Lahontan Regional Water Quality Control Board

REVIEW OF CHROMIUM PLUME MAPS, THIRD QUARTER 2013 GROUNDWATER MONITORING REPORT AND AGREEMENT WITH NORTHERN INVESTIGATION CONCEPT, PACIFIC GAS AND ELECTRIC COMPANY, HINKLEY, SAN BERNARDINO COUNTY (CLEANUP AND ABATEMENT ORDER NO. R6V-2008-0002A4) WDID 6B369107001

REQUEST FOR AN ACTION PLAN AND MORE INFORMATION IN REPORTS REQUIRED BY CLEANUP AND ABATEMENT ORDER NO. R6V-2008-0002 AND INVESTIGATIVE ORDER R6V-2013-0041

PACIFIC GAS AND ELECTRIC (PG&E) COMPRESSOR STATION, HINKLEY, SAN BERNARDINO COUNTY (WDID 6B369107001)

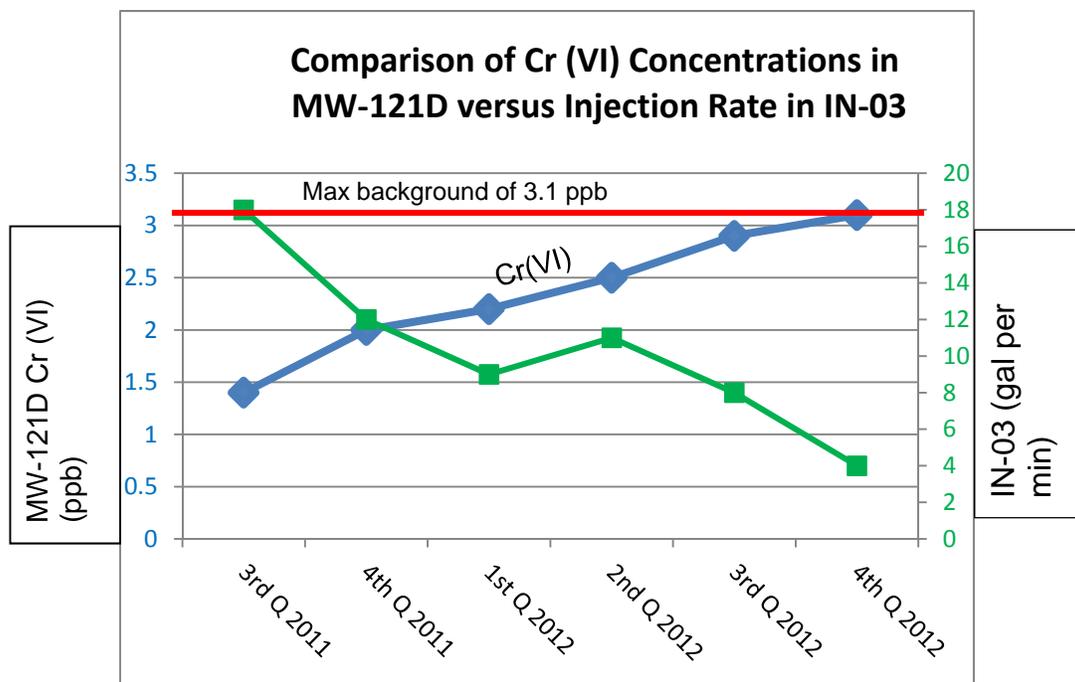
c. Amend Table 2-11 to show the total calculation of all columns for the quarter being reported.

The revised Table 2-11 contained in Attachment 1 to the report was not amended to include the total calculations during first quarter 2013 for four columns: total days in period pumping, % of period actively pumping, average injection rate when pumping, and average injection rate for period.
